Re: MADEP File No. 301-1227
Abbreviated Notice of Resource Area Delineation Response to Comments
Sudbury-Hudson Transmission Reliability Project

Nover-Armstrong Comments

Mr. David Burke Comments

Sudbury Conservation Commission Comments

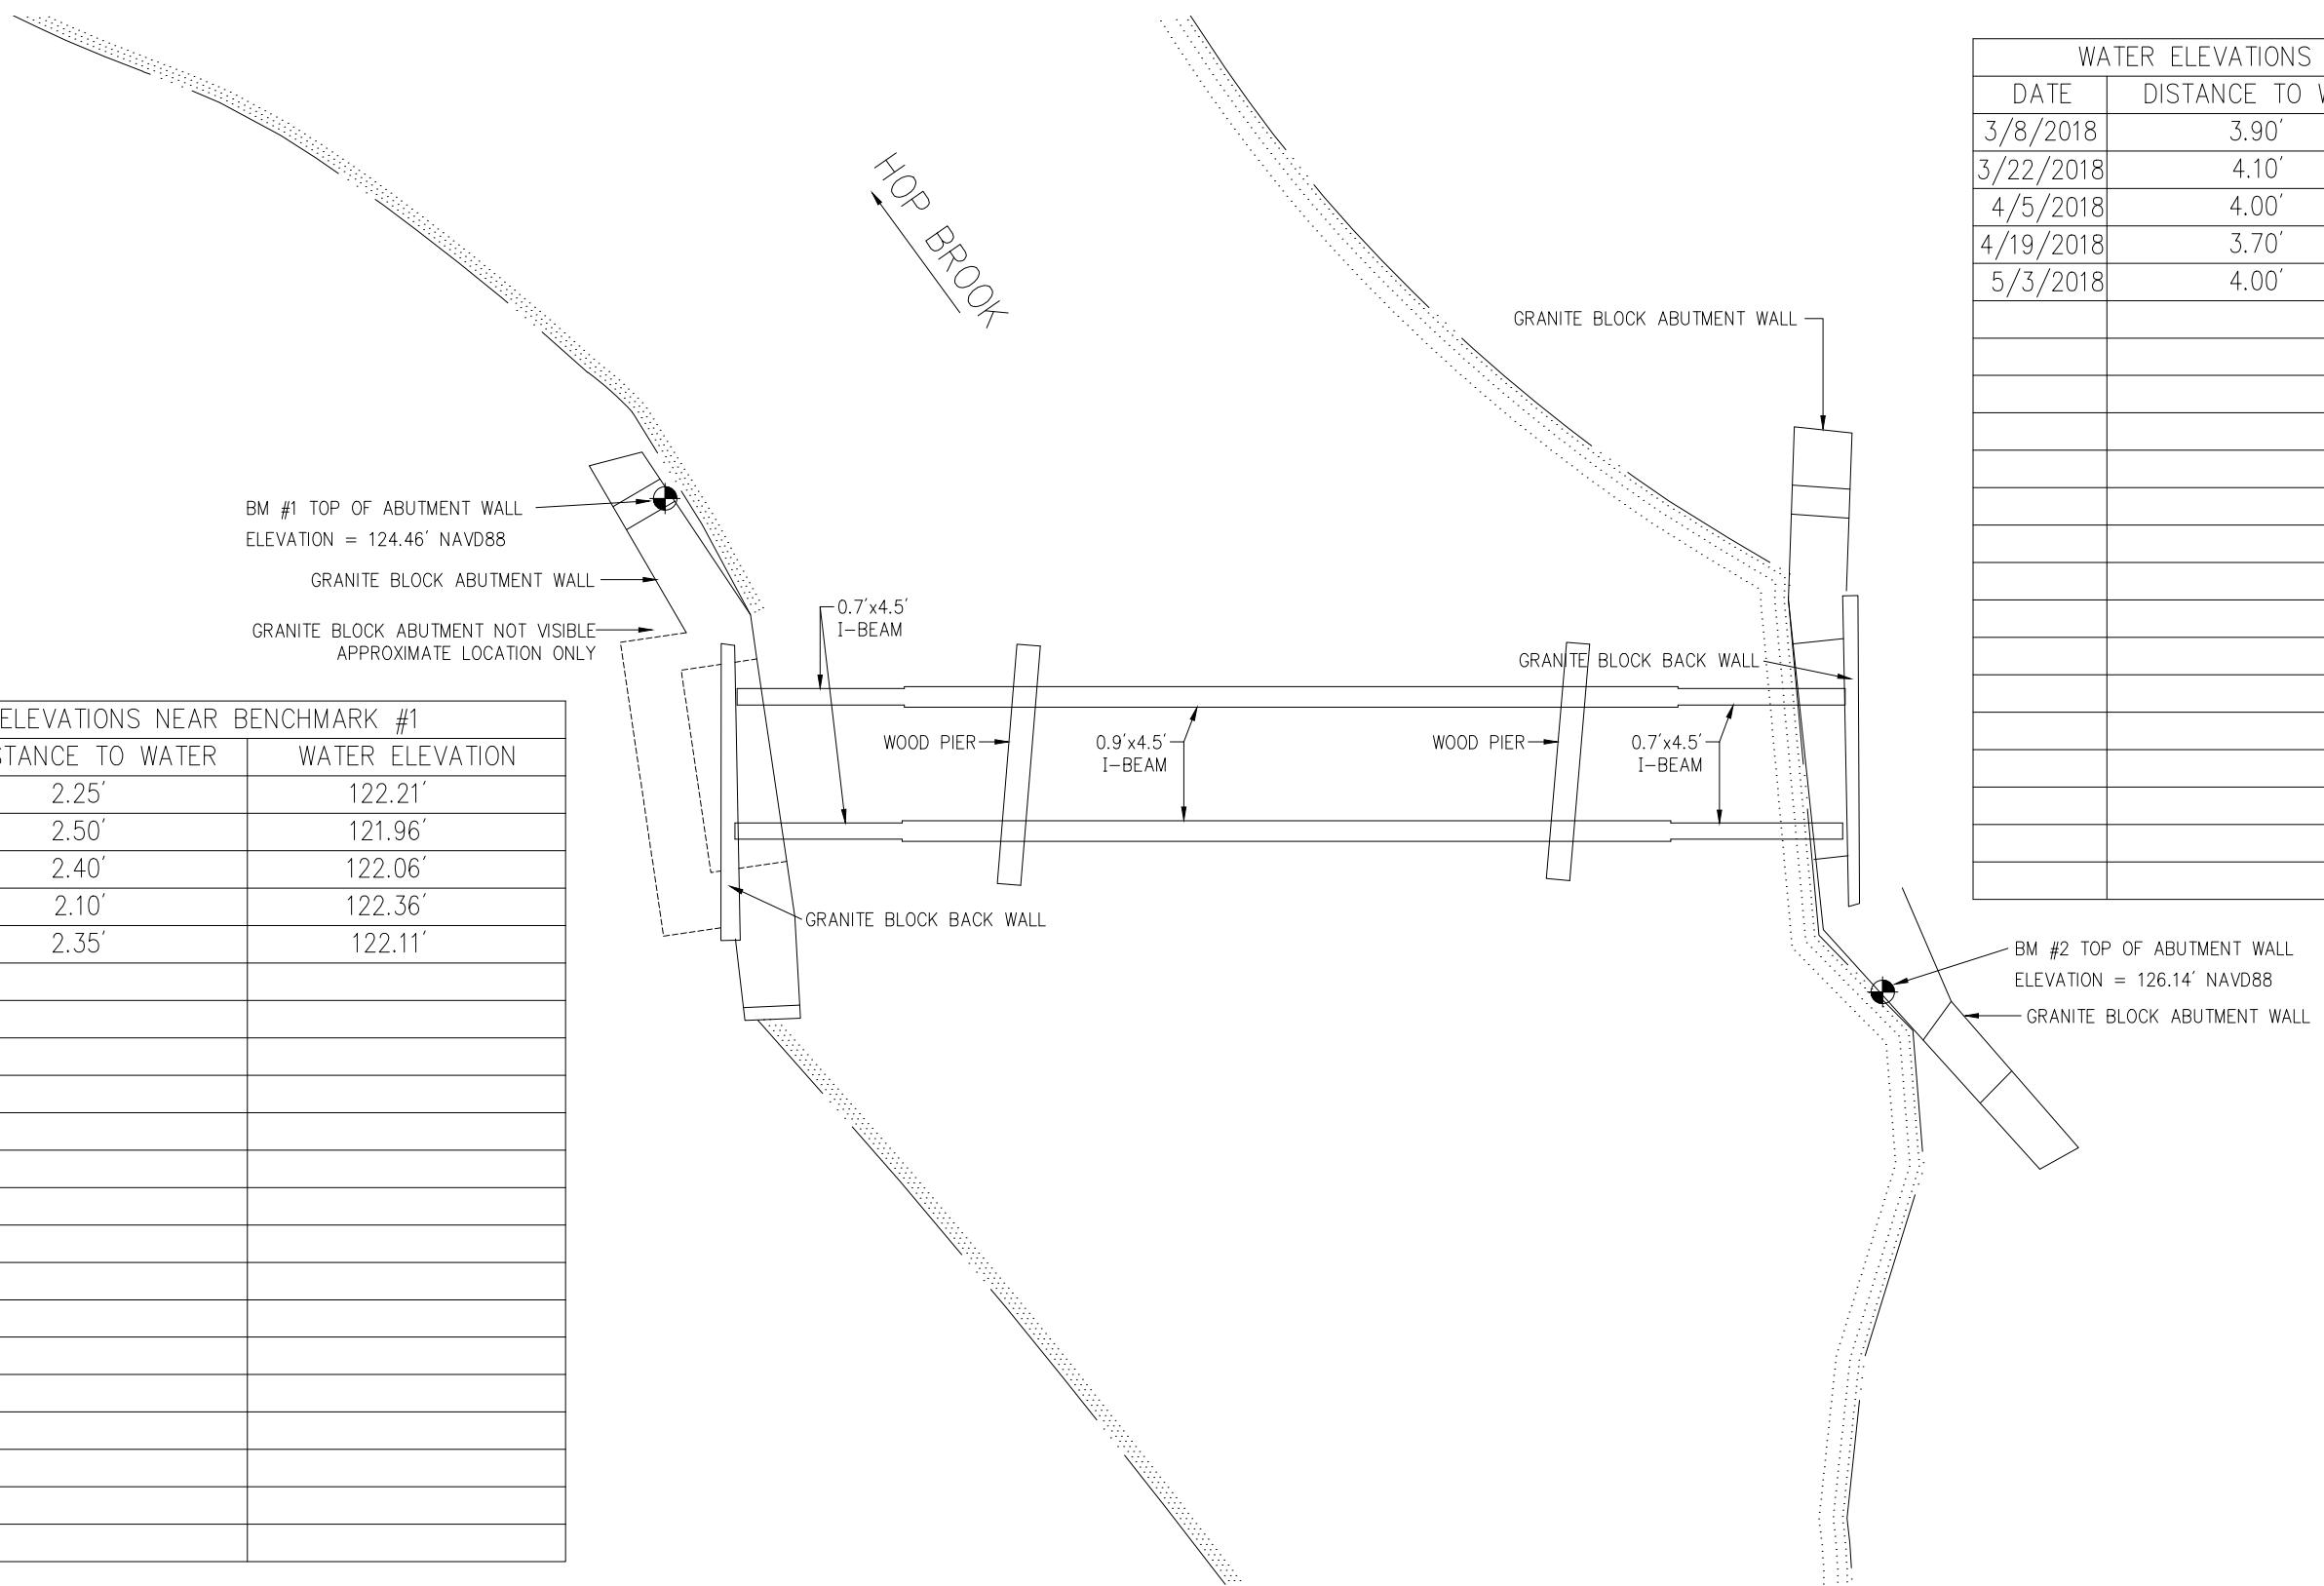
- 8. The culvert between Wetlands 18 and 19 on sheet 31 is not functioning and Wetland 19 is isolated. Mr. Burke believes that Wetland 19 could be a potential vernal pool.**

This was reviewed in the field with Mr. Burke and a discussion was held regarding its potential as a vernal pool. At the time of the site visit, there was standing water present; however, there was a significant rainfall event the previous day and it was difficult to assess true field conditions. Both parties (Mr. Burke and VHB) felt that the isolated wetland likely **does not** hold water long enough (2 months) to meet the criteria for a vernal pool. VHB visited Wetland 19 on April 24 and the water level had significantly receded, which indicates that it does not hold enough water for the required two-month time period.

**Water Elevations Under Bridge 127 Over Hop Brook
Sudbury, Mass.**

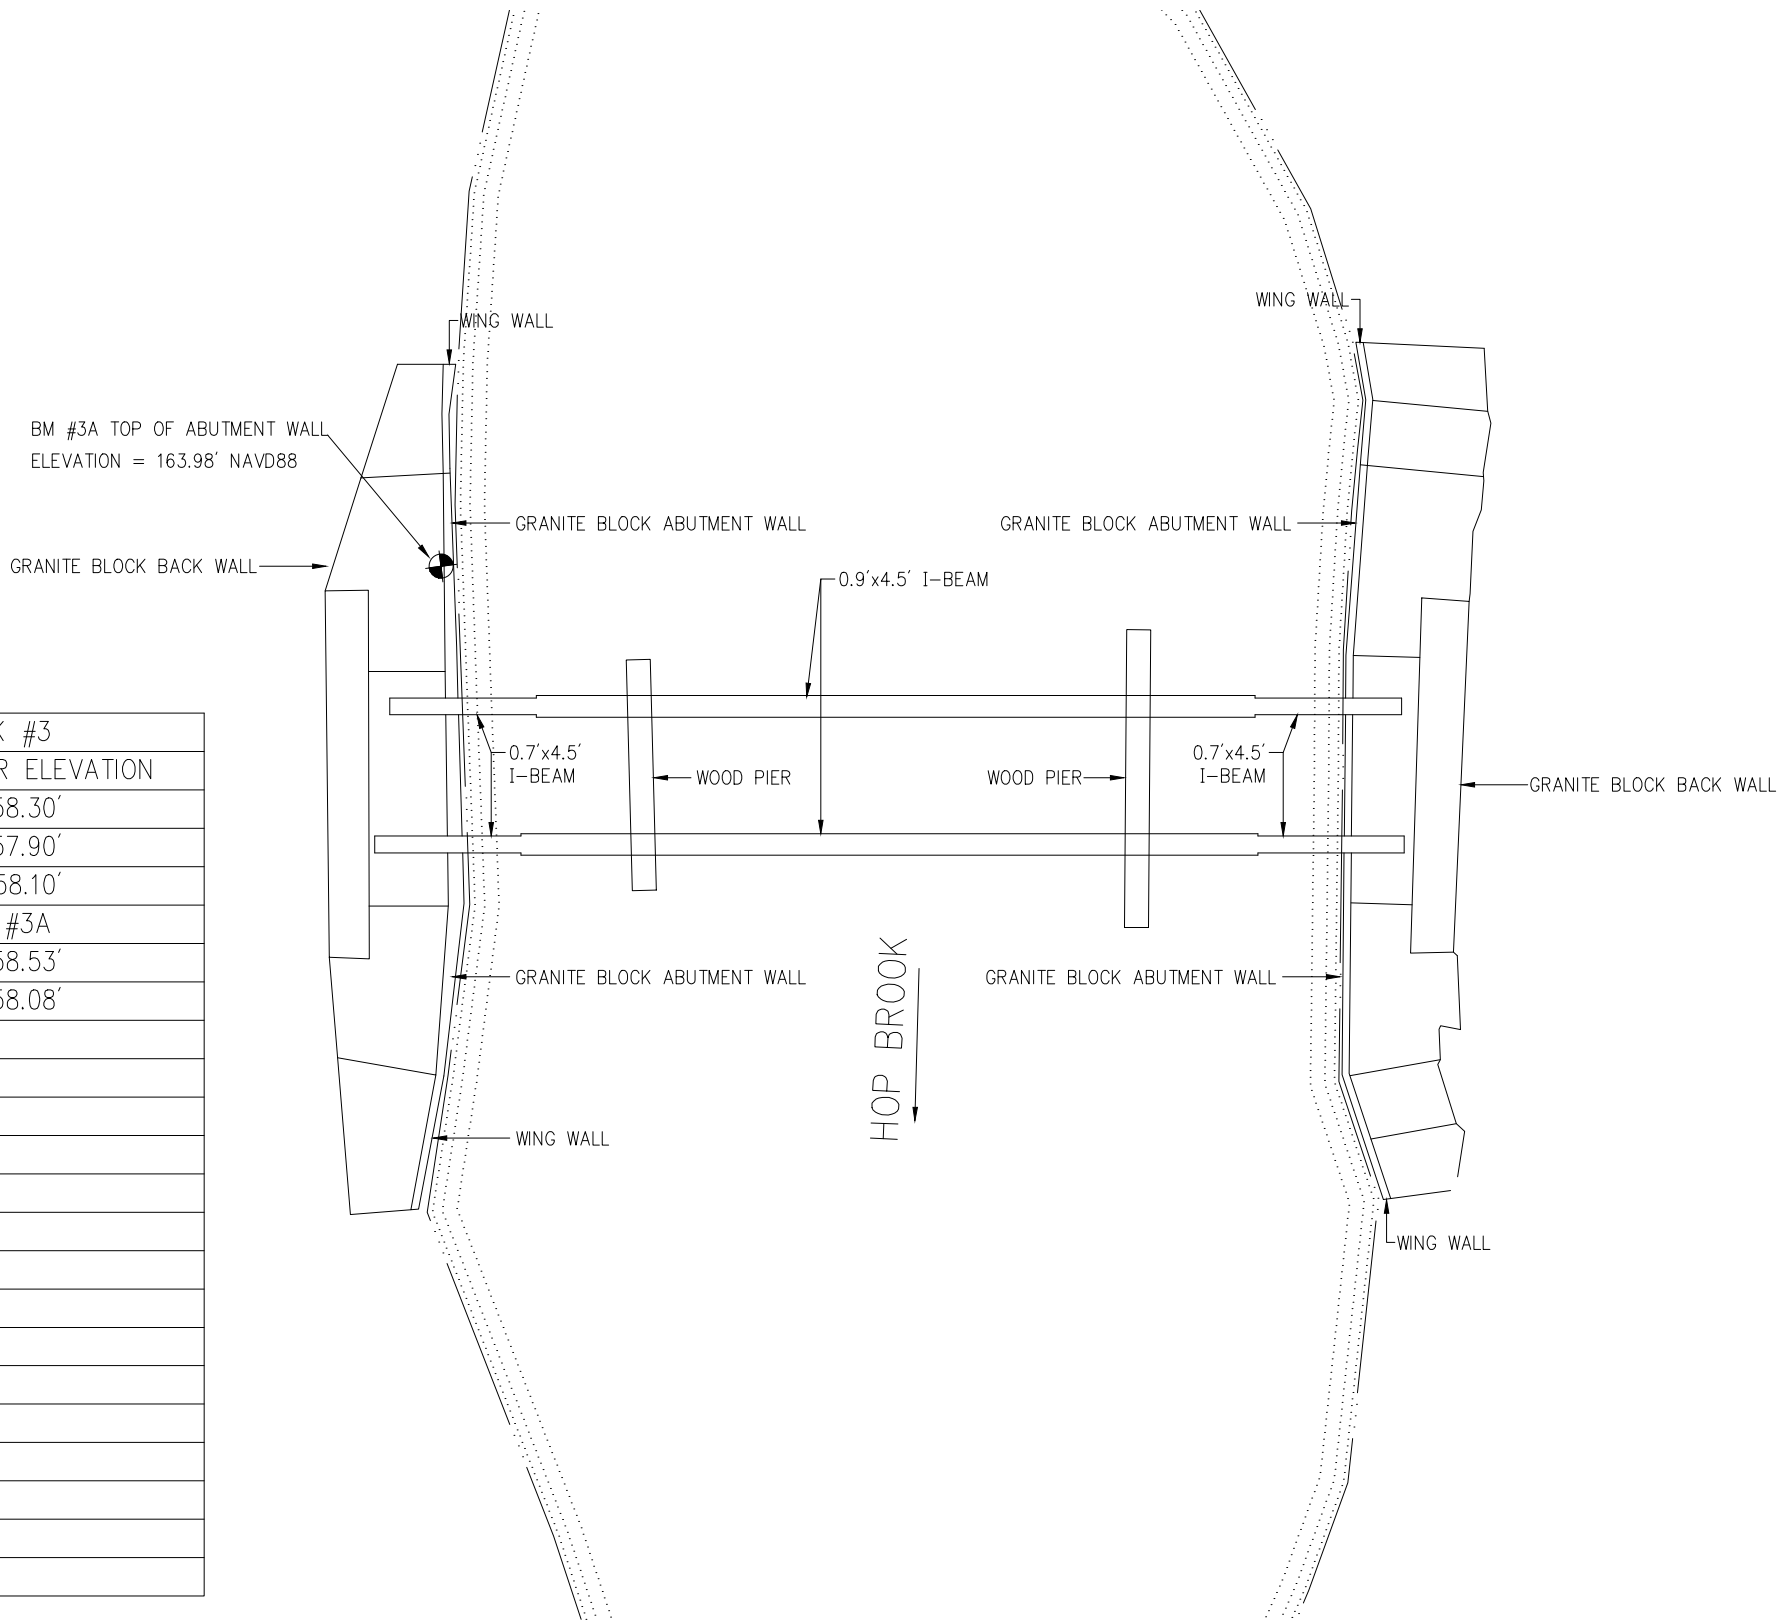
2. Nover-Armstrong requested that the current water elevation for the eastern Hop Brook crossing be provided to compare to the FEMA mapping. In addition, they requested that a benchmark be established so the surface water elevation can be measured and monitored for changes.

VHB established two (2) benchmarks at the eastern Hop Brook crossing. Benchmark 1 is located upstream of the bridge on the top of the western abutment wall and is at elevation 124.46-ft

(NAVD88). Benchmark 2 is located downstream of the bridge on the top of the eastern abutment wall and is at elevation 126.14-ft (NAVD88). One (1) benchmark was established at the western Hop Brook crossing upstream of the bridge on the eastern abutment wall and is at elevation 166.80 (NAVD88) All benchmarks are physically marked in the field with pink paint and VHB is surveying water elevation data once every two weeks. Please see the attached figures with the benchmark locations and water elevation data at both bridge locations for additional information.
